June 28, 2016

**Re: Notice of Minor Proposed Alteration
Licence and Minor Clause Change
Rice Lake Gold Mine - Environment Act Licence 2628RR
Klondex Canada Ltd.**

Attachment 1

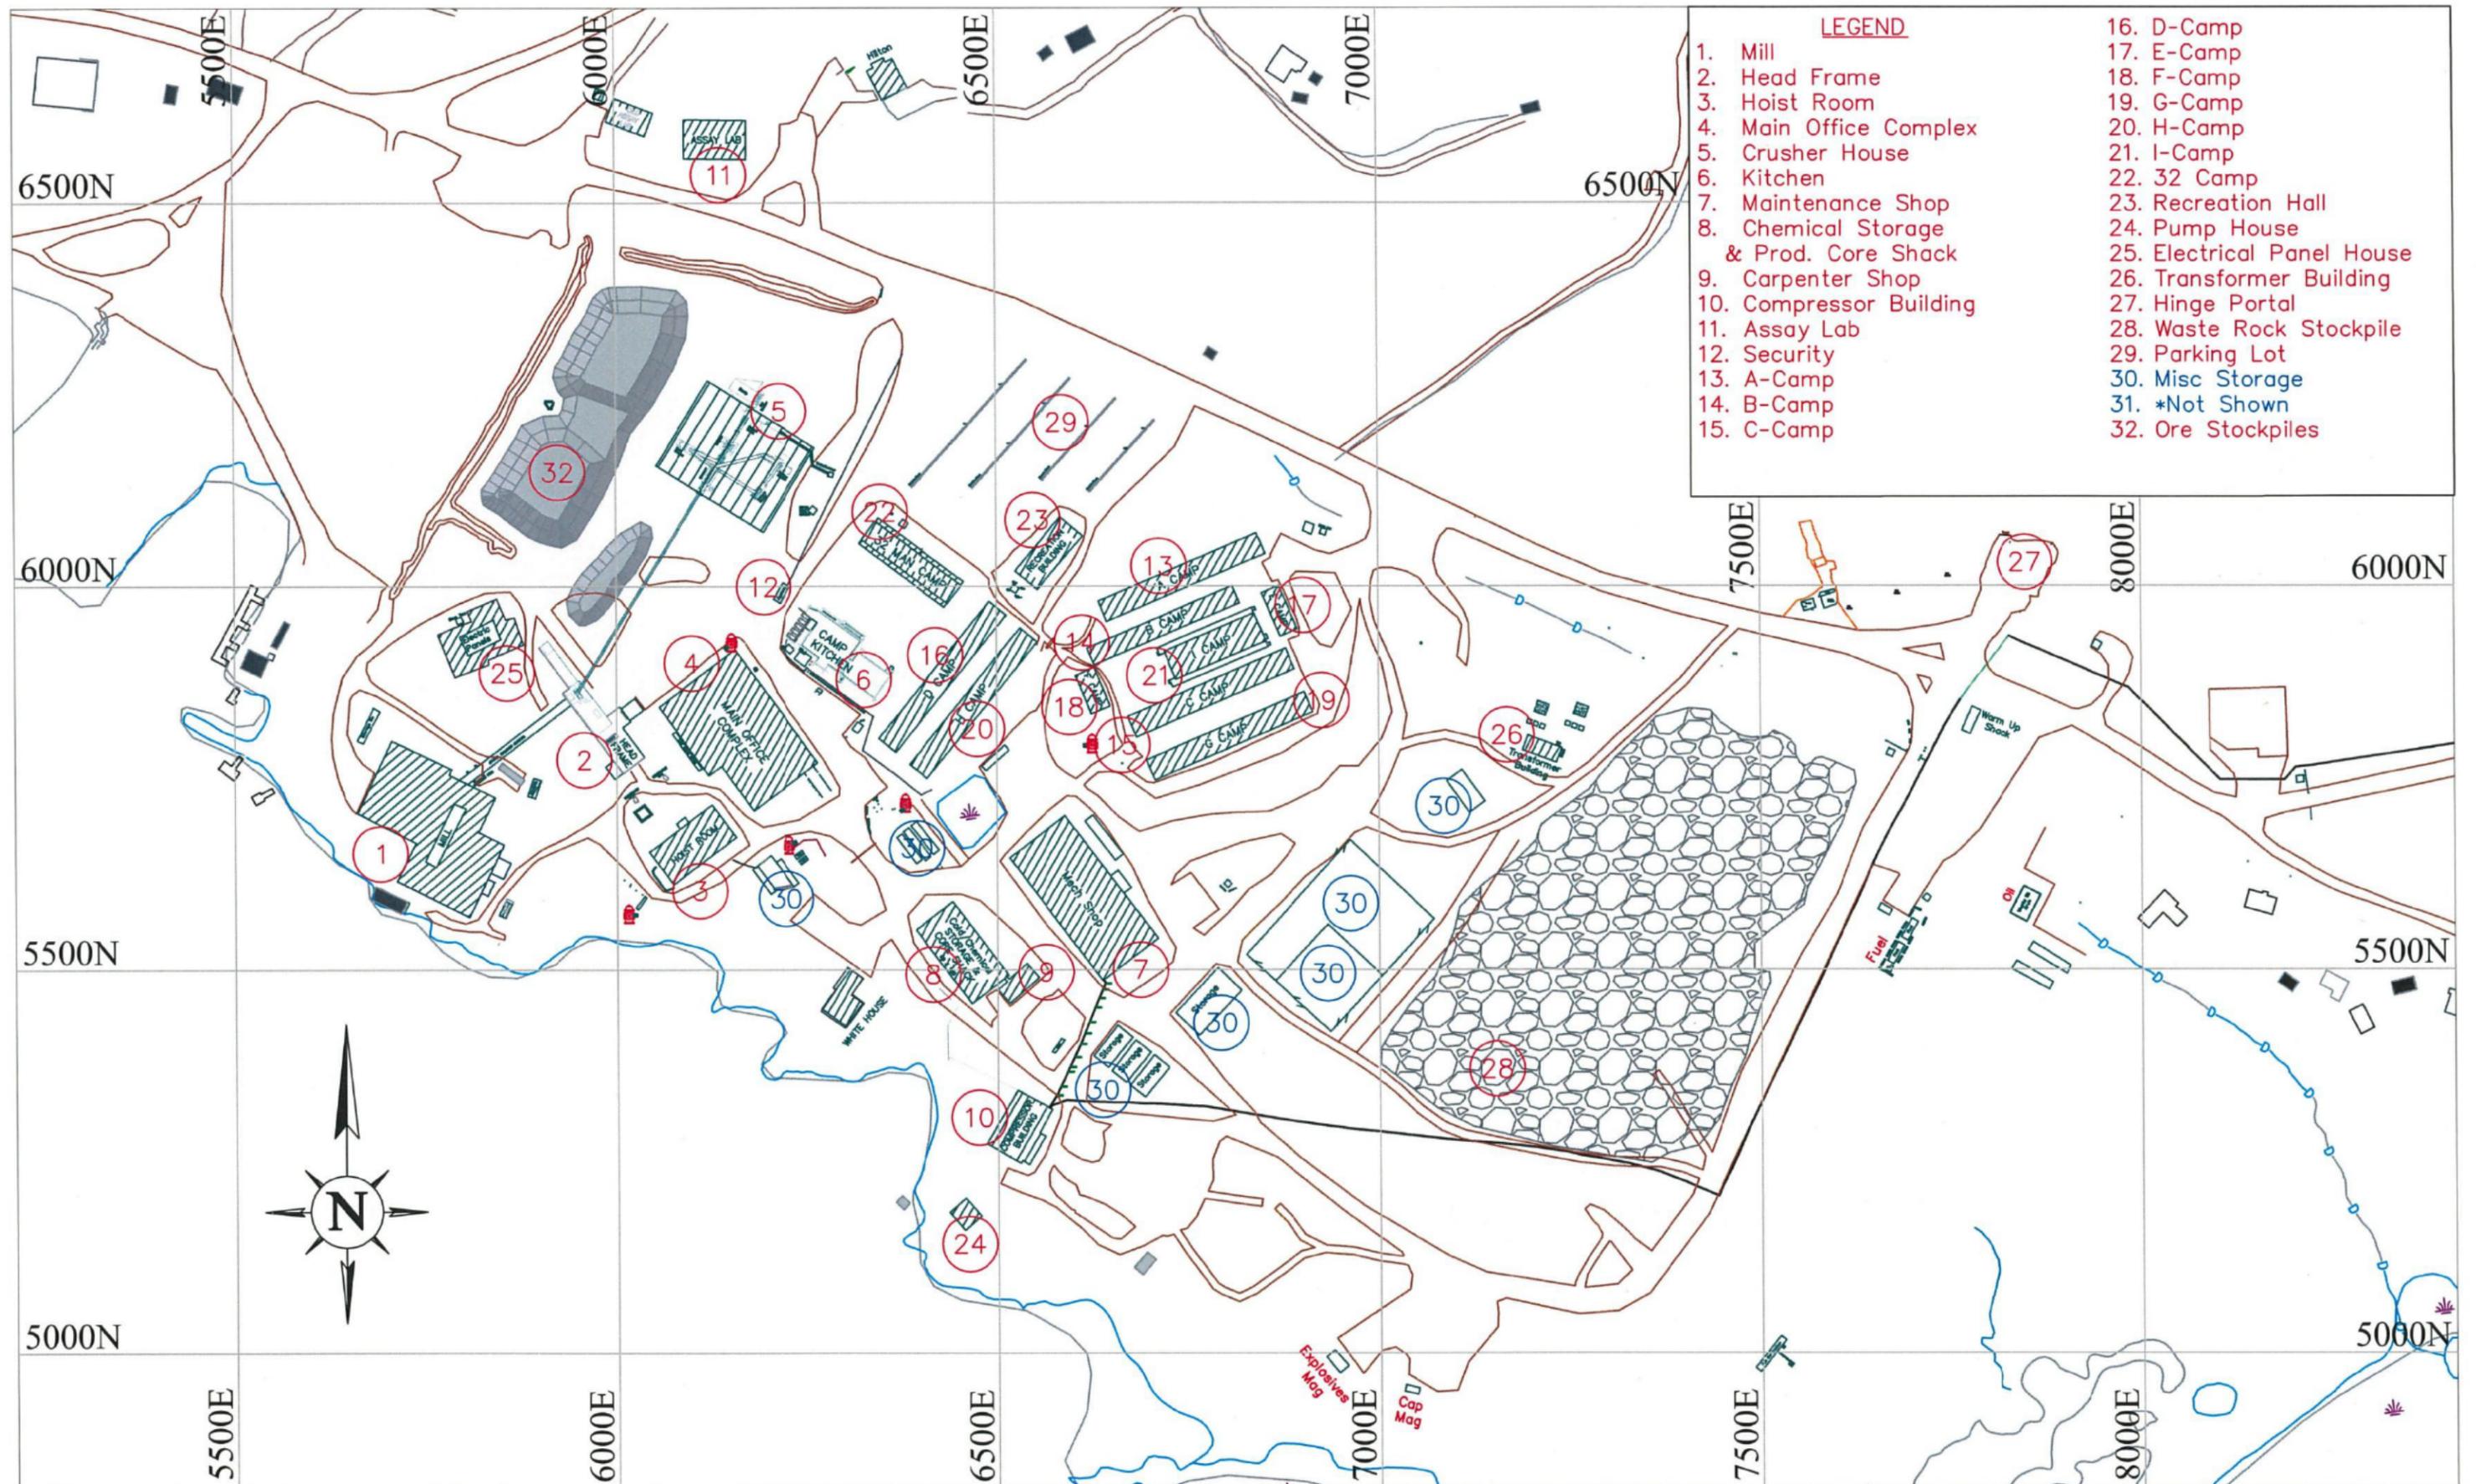
Klondex is proposing that Environmental Act Licence 2628RR has the Licencee changed from San Gold Corporation to Klondex Canada Ltd. to reflect the recent acquisition of the Development by Klondex. In addition, the Development will be known as the “True North Gold Mine”. Past Development names such as Bissett Gold Mine and Rice Lake Mine will no longer be used to refer to the Development. An updated plan of the True North Gold Mine is included on Attachment 1. In addition, the Rice Lake Mine shaft will also be named the True North Gold Mine.

Attachment 2

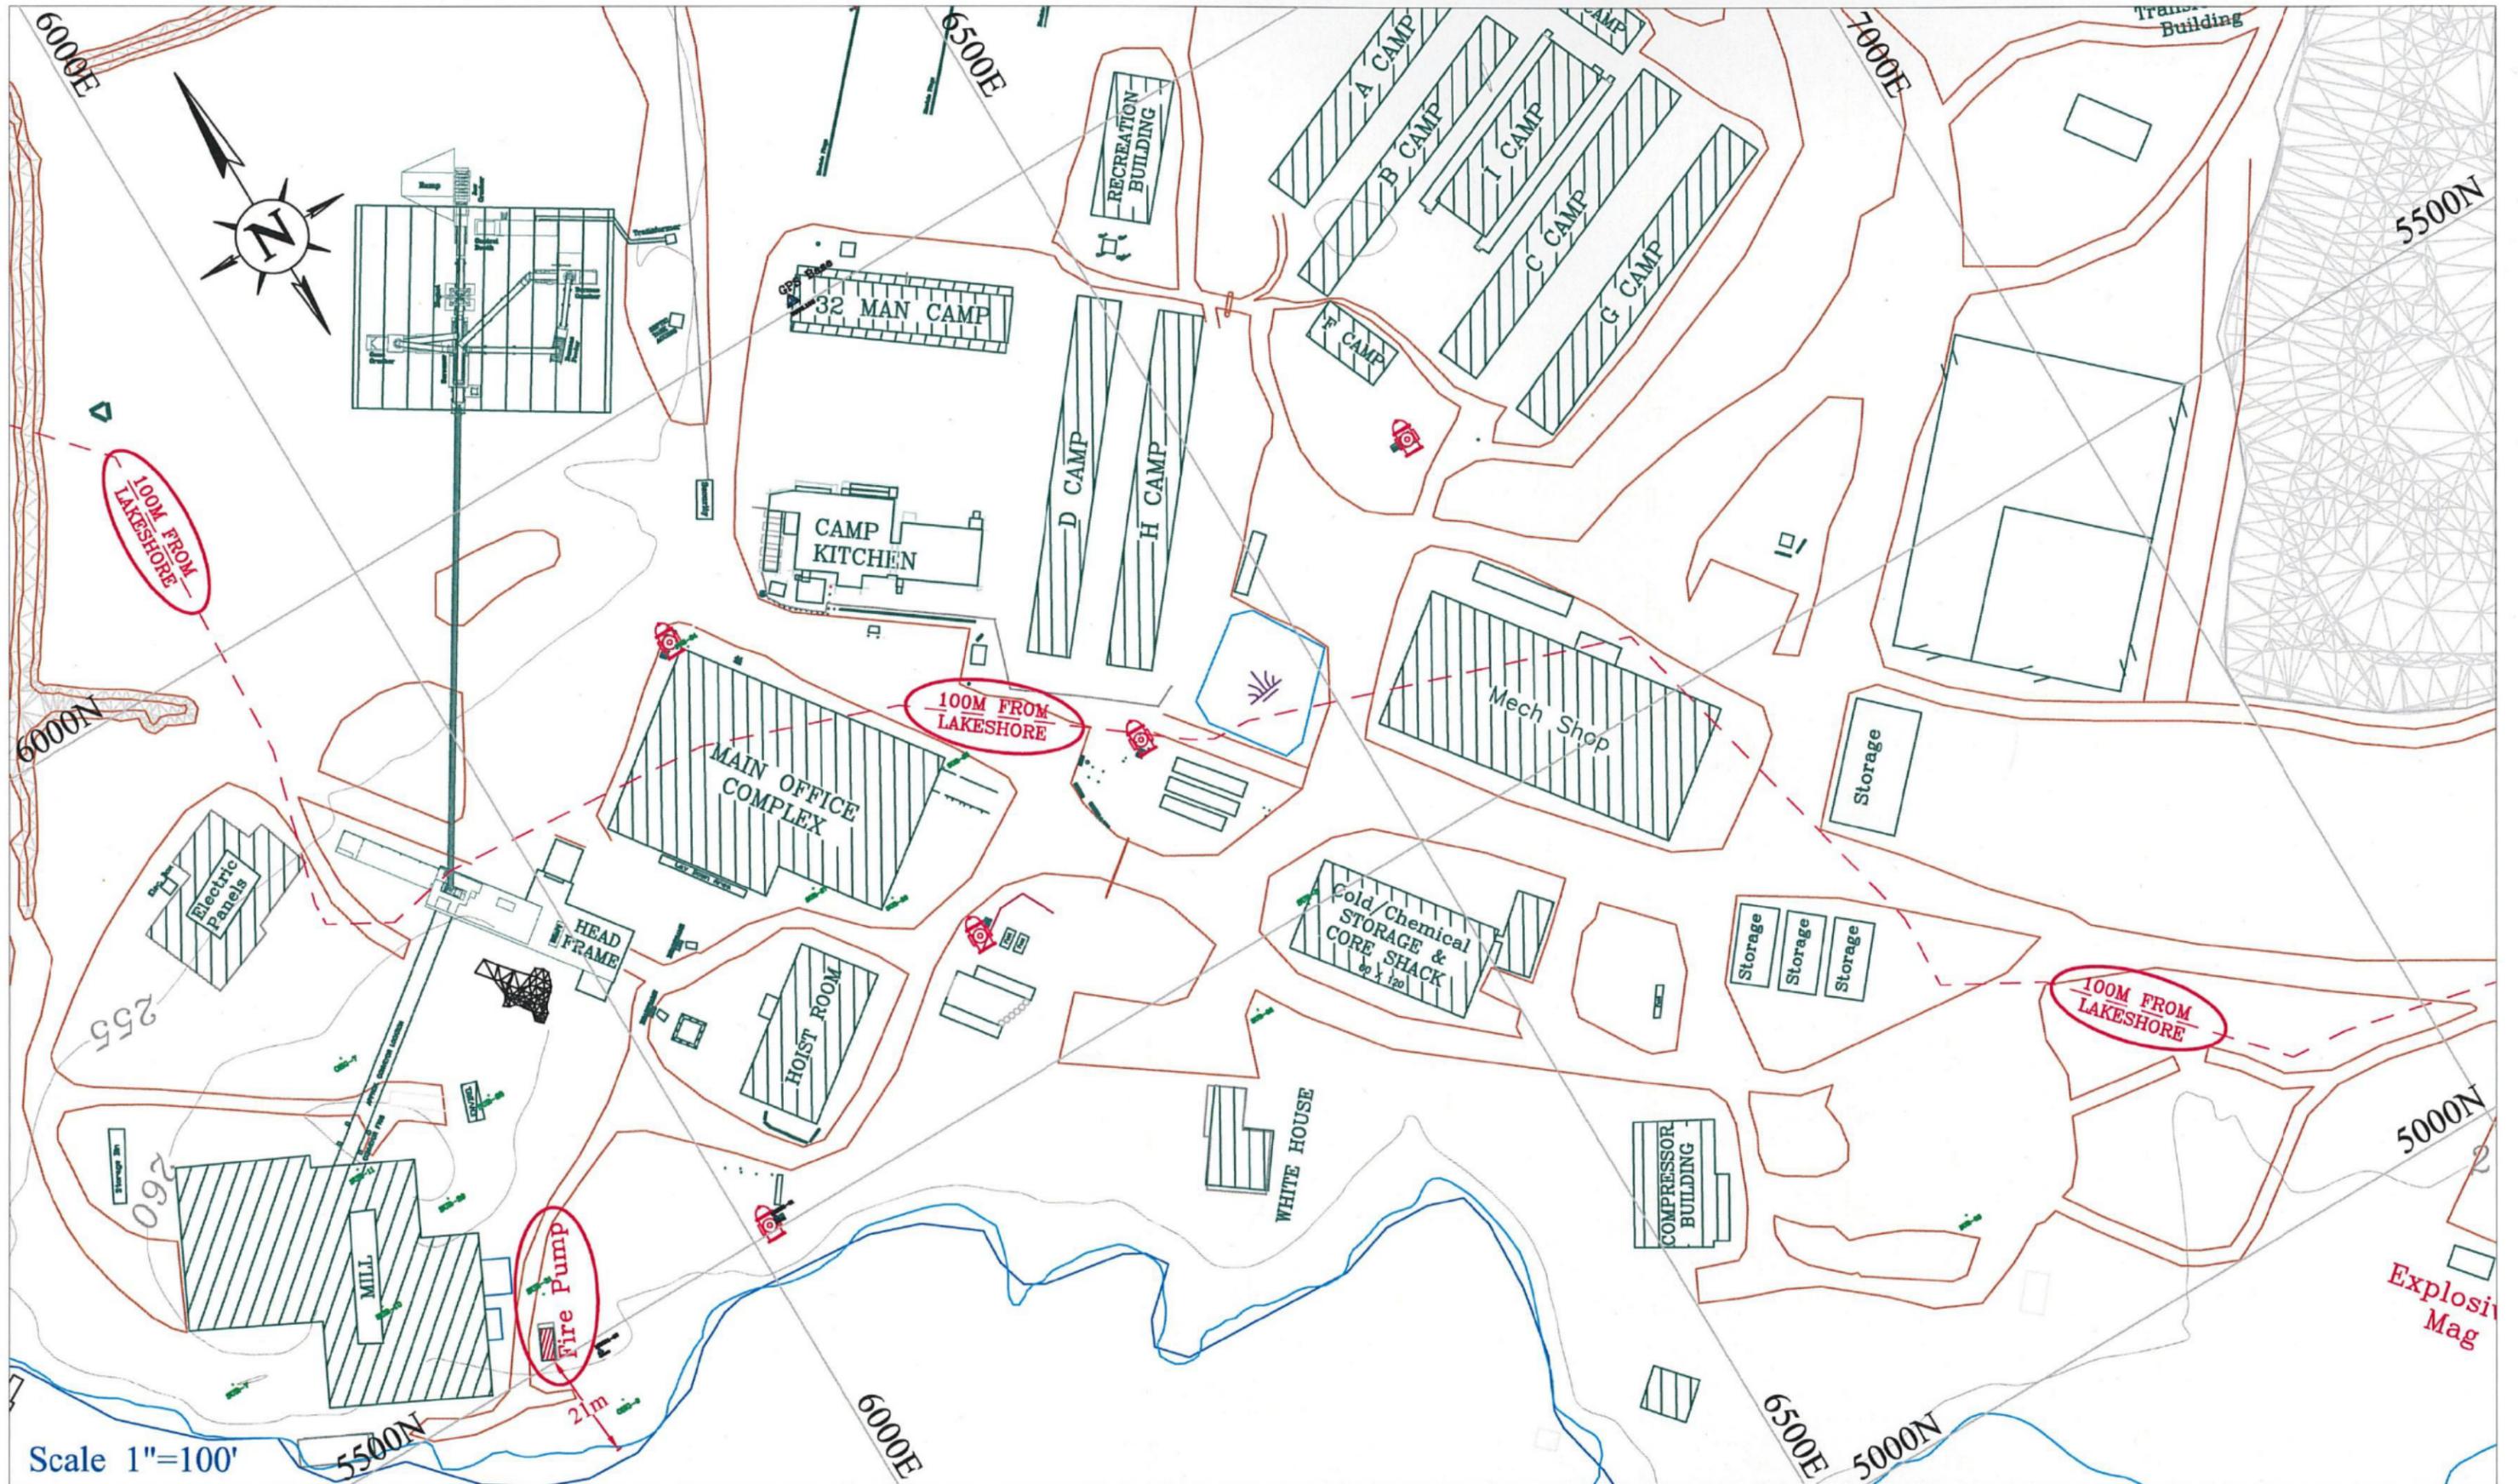
Klondex is requesting an alteration to clause 25 to allow for a 682-litre diesel tank and secondary containment of 110% that is located within the 100-meter buffer zone from Rice Lake. The diesel tank is used to supply fuel to the emergency fire pump for the Mine's hydrant system and was constructed previous to Klondex ownership of the Mine. Both the pump and diesel tank are enclosed within a sea container and spill response material is located adjacent to the sea container. The fire pump is located 21 meters from the lakeshore as shown on Attachment 2.
